June 28, 2007

RE: REVISED SOURCE ZONE REMEDIATION PLAN ADDENDUM, FUEL LEAK CASE NO. RO0000278, DESERT PETROLEUM, 2008 1ST STREET, LIVERMORE, CALIFORNIA

SITE PLAN
FIGURE 1

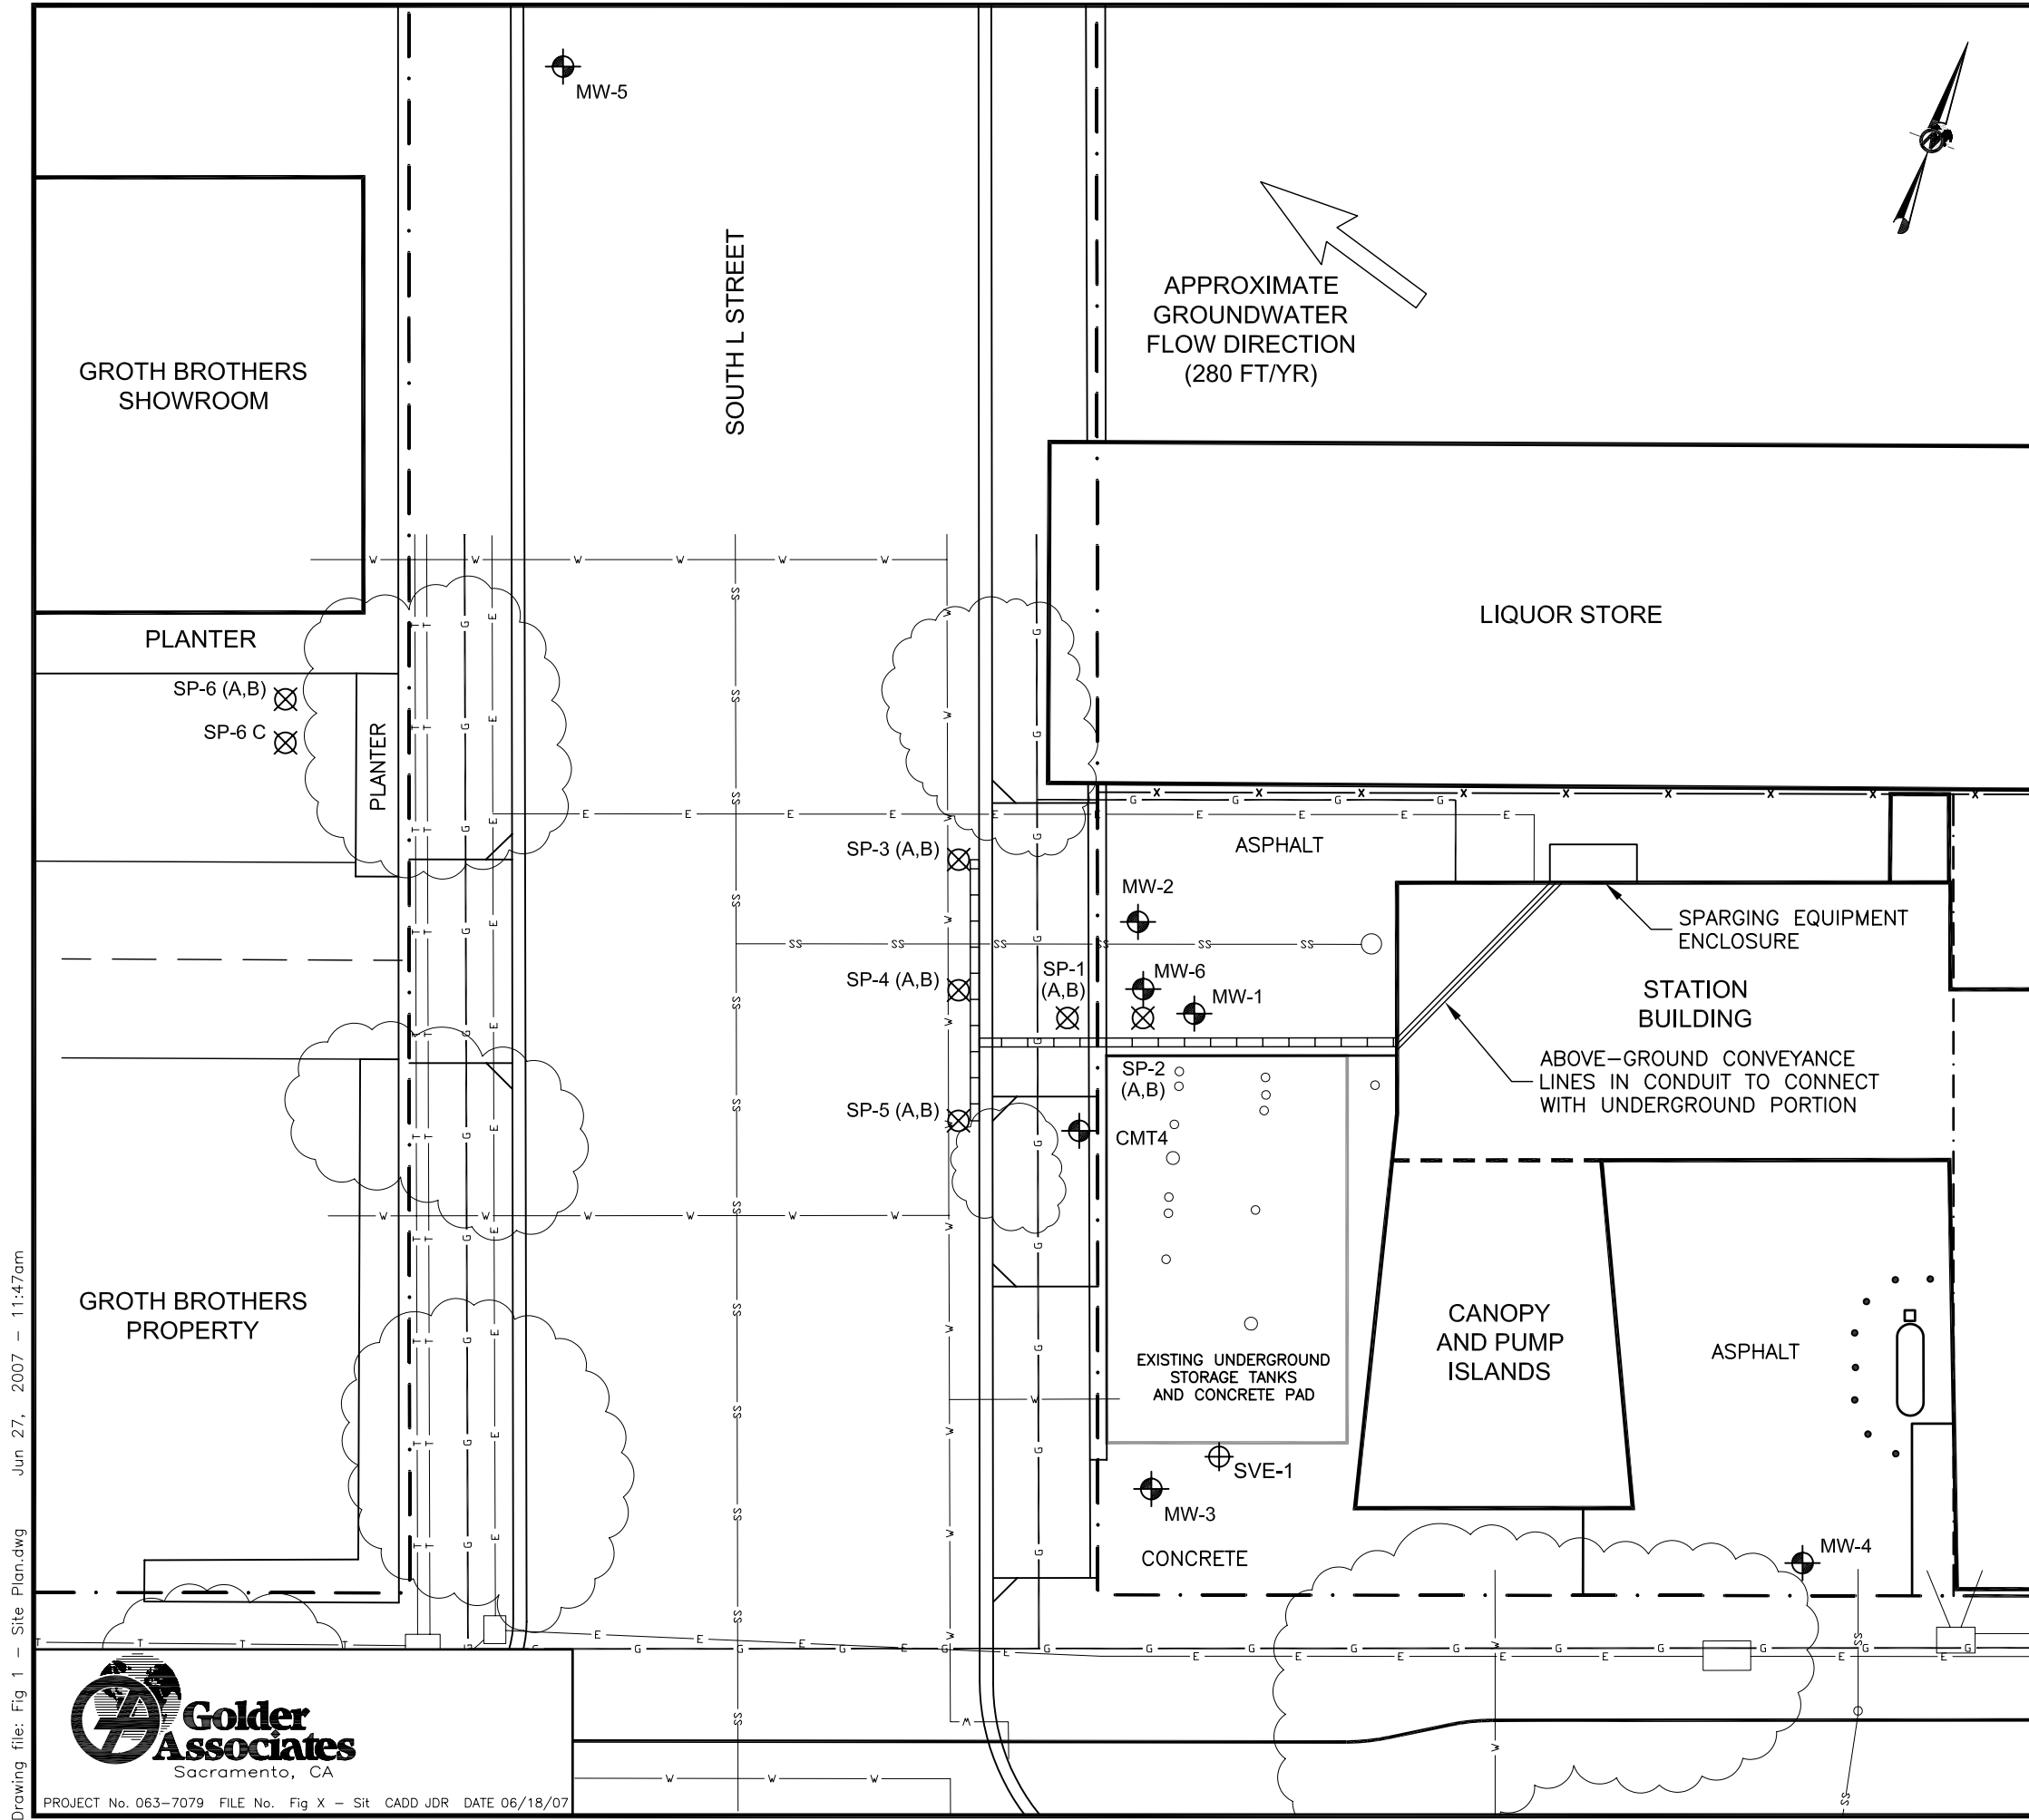
ACEH did not concur with the cleanup levels nor the exclusion of source zone remediation on the Desert Petroleum site in the remediation plan proposal. The addendum needs to include your discussion of your plan to expand the system to address source zone cleanup on both the Groth and Desert Petroleum sites (e.g., following pilot test evaluation) and to establish clean up levels and goals for contaminants at the sites. (Reference: directive letter dated March 26, 2007, Technical Comments A.1. and A.7.) (May 25, 2007)

As described below (response to comment 2.d.), Golder proposes expanding the pilot test at the Desert Petroleum (DP) site. Depending on the results of the pilot test, the remediation approach may include additional ozone/air sparging wells on the DP site and/or the installation of SVE wells. These additional wells may be installed between the underground storage tanks (USTs) and the pump

islands or on the east side of the pump islands (Figure 1). On the Groth Brothers property, Golder will evaluate the installation of separate equipment to avoid trenching beneath the street and the installation of additional ozone/air sparging wells consistent with the results of the pilot test. The installation of additional ozone/air sparging wells on the Groth Brothers site will be dependent on coordination with the upcoming development and access constraints.

**OZONE/AIR SPARGE
WELL SCHEMATIC**

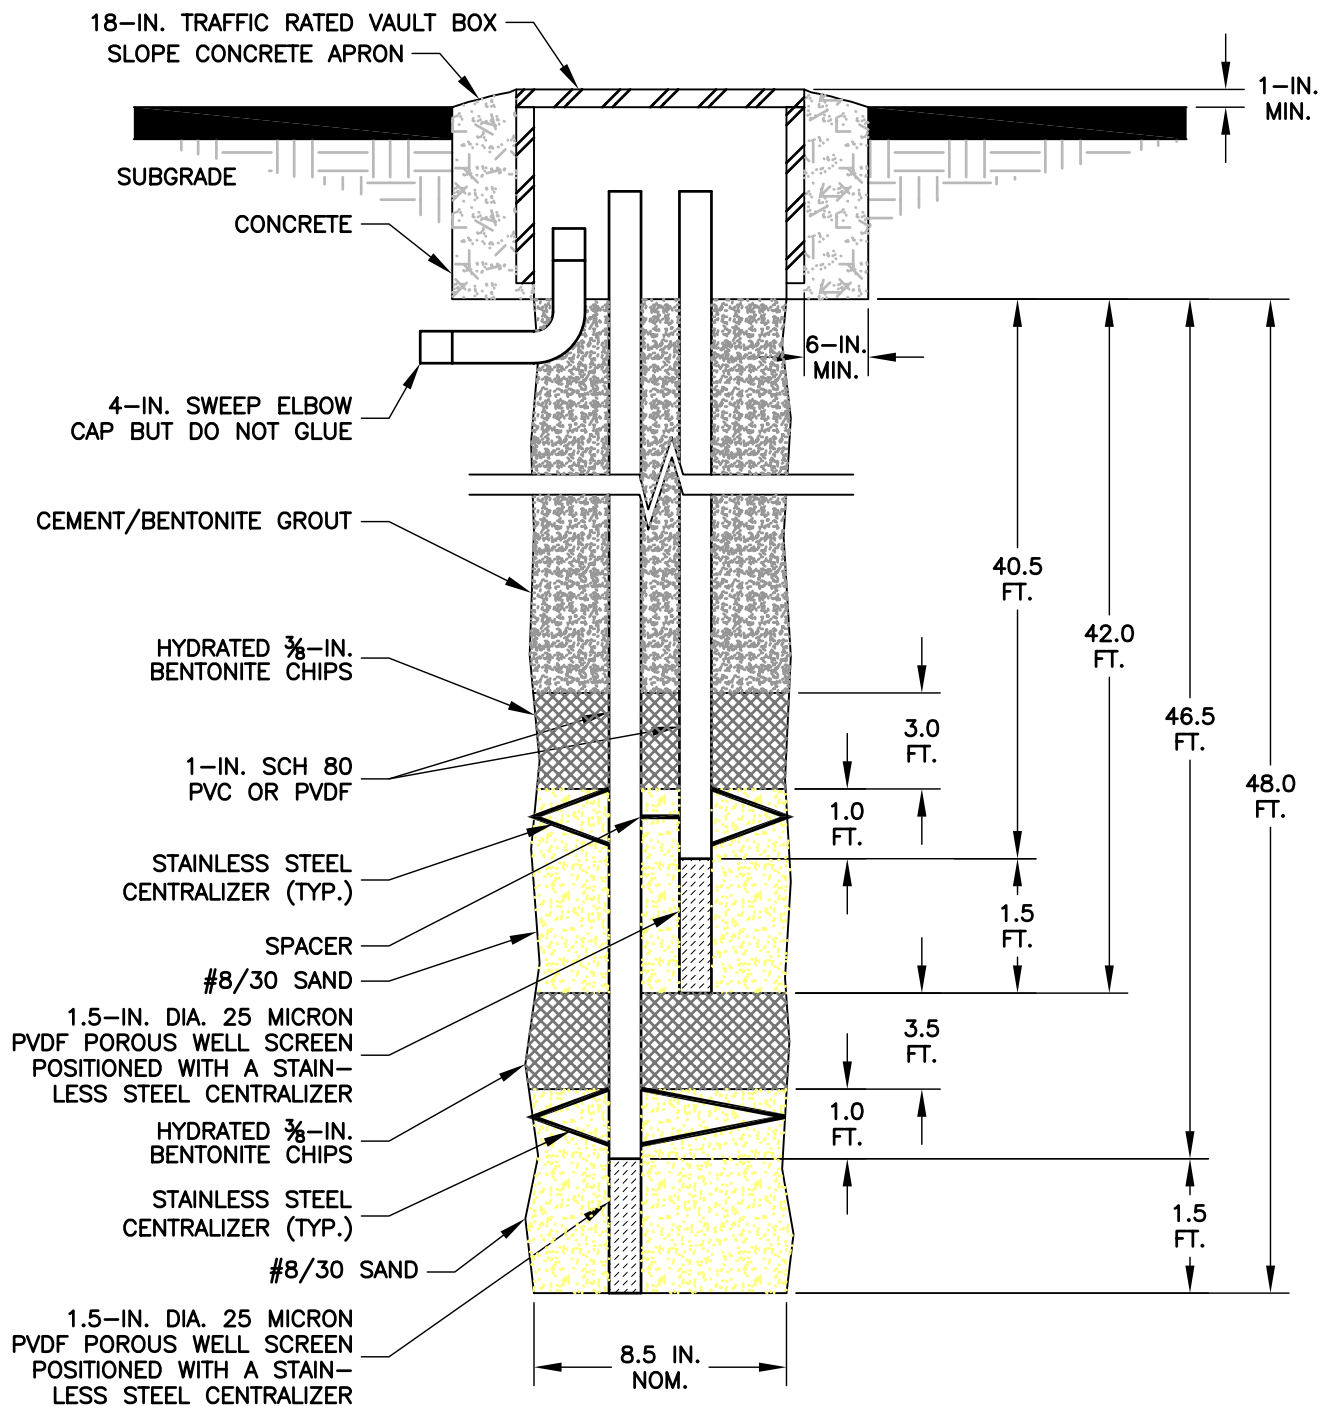
Golder proposes the installation of nested wells for their treatment system. Nested wells are not acceptable at contaminated sites due to the difficulties in ensuring reliable seals between sampling zones. Poor seals can result in leakage between zones and are therefore not allowed. We request that you consider an alternative design for these wells. (March 26, 2007)

Include graphics that demonstrate how the nested injection wells will be constructed to maintain separation of multiple casings ensuring reliable seals between sampling zones. (May 25, 2007)

Golder proposed nested ozone sparging wells for this pilot test for the following reasons:

- The target zone is sufficiently thick that if a sparge well was constructed over the entire length, the higher hydrostatic pressure at depth would force the sparge gas through the upper portion of the screen and no treatment would be accomplished in the lower part of the target zone. Therefore, installing two shorter sparge wells at different depths will provide more efficient distribution of the sparge gas.

- Installing separate sparge wells approximately 3 to 5 feet apart would require twice as many penetrations of the road surface within the City of Livermore easement and more trenching and resurfacing to connect the sparge conveyance lines.

- The sparge wells are not going to be installed across an aquitard or zone of lower permeability material such that cross-contamination may be encouraged. The geologic materials across the entire length of the target sparge zone are consistent and described as coarse-grained material.¹⁷

- The sparge wells will be installed using stainless steel centralizers and a spacer to maintain the sparge wells and casing materials in positions away from the boring sidewalls and each other within the seal materials to improve the seal between the two sparge points. Golder proposes to install a 3.5-foot thick bentonite seal between the two sparge points.

The nested sparge well construction diagram showing the spacer and centralizers proposed by Golder to ensure adequate seal is shown on Figure 2.

GEOLOGIC CROSS SECTION D-D'

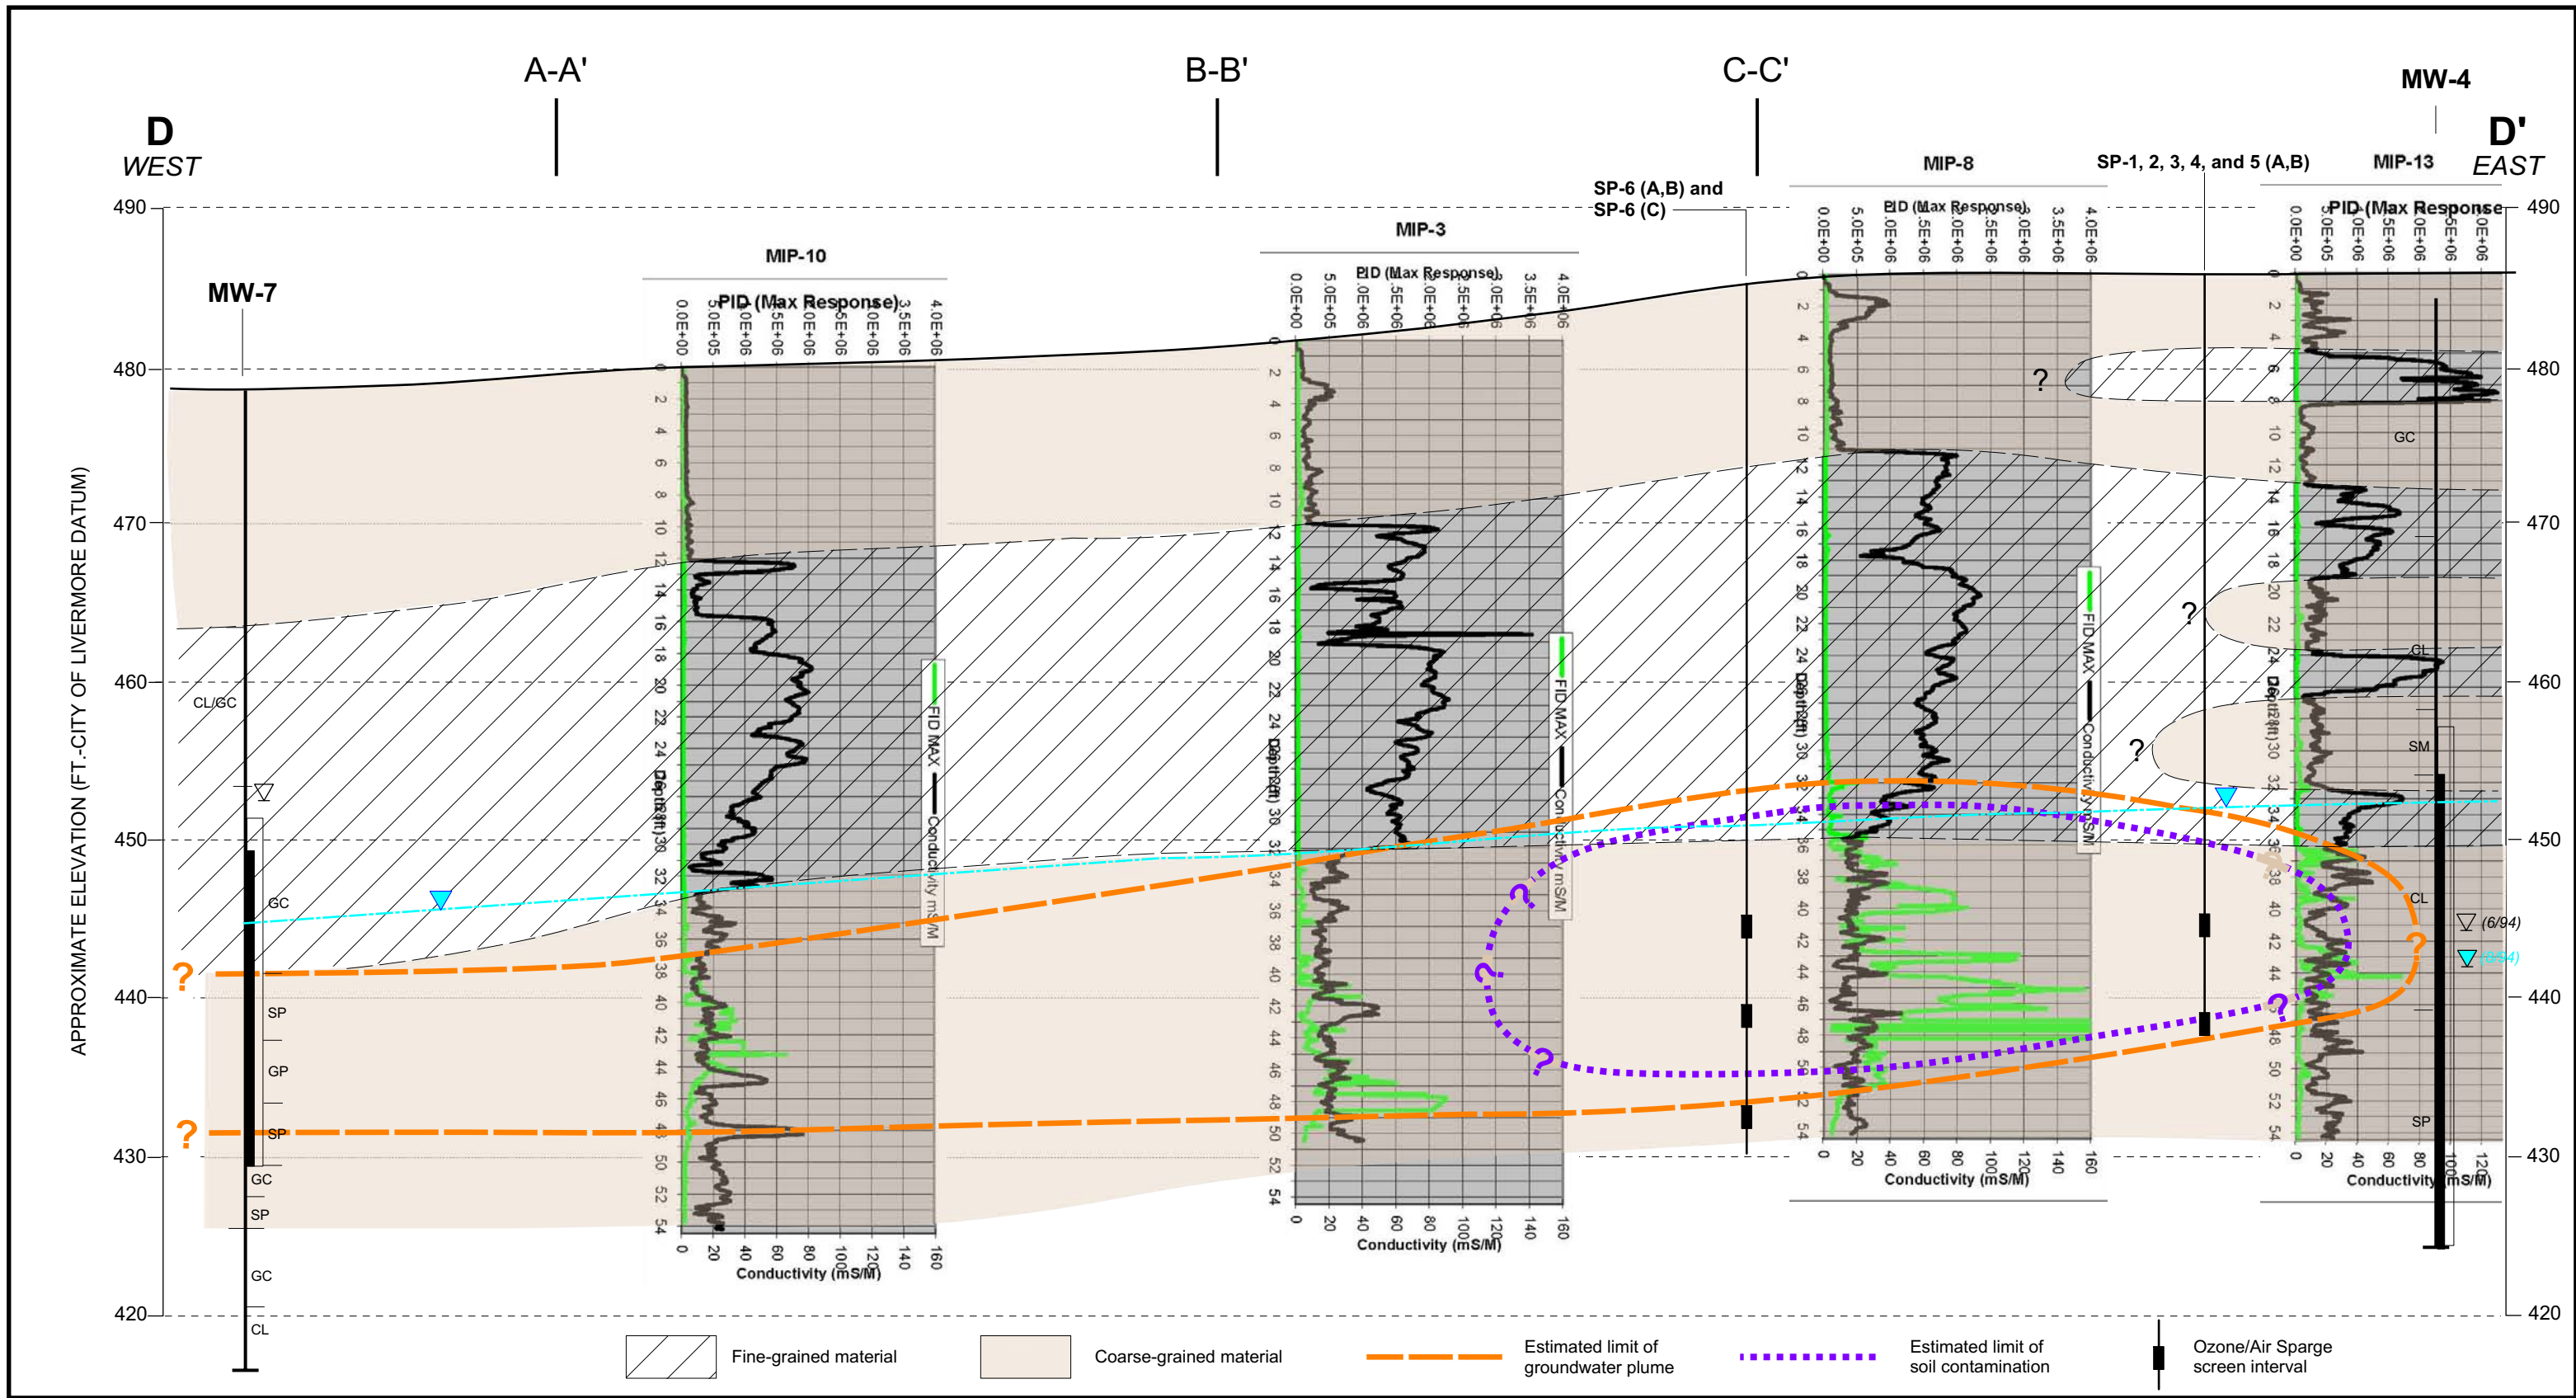
Options for design and location of an additional short screened monitoring network (small diameter direct push, CMT, etc.) capable of collecting data to evaluate the effectiveness of the treatment system was discussed during the meeting. Please finalize your proposal for this network. Include your rationale for the network design and specify the data to be collected to evaluate treatment system effectiveness, differentiate plume displacement verses mass destruction etc. Include graphics for well location and design. (May 25, 2007)

In addition to the three originally proposed dual-completion ozone/air sparging (SP) wells, Golder proposes installing two additional SP wells on the DP site and one SP well on the Groth Brothers property, SP-1 (A, B) through SP-6 (A, B) (Figure 1). These SP wells will be constructed consistent with the SP wells proposed in the source zone remediation work plan and as shown in Figure 2. Golder also proposes installing an additional single-completion SP well next to SP-6 (SP-6C) that will be screened at approximately 52.5 to 54 feet bgs as shown in Figure 3. The screen depths of the sparging wells are shown on cross section D-D' from the investigation report on Figure 4.
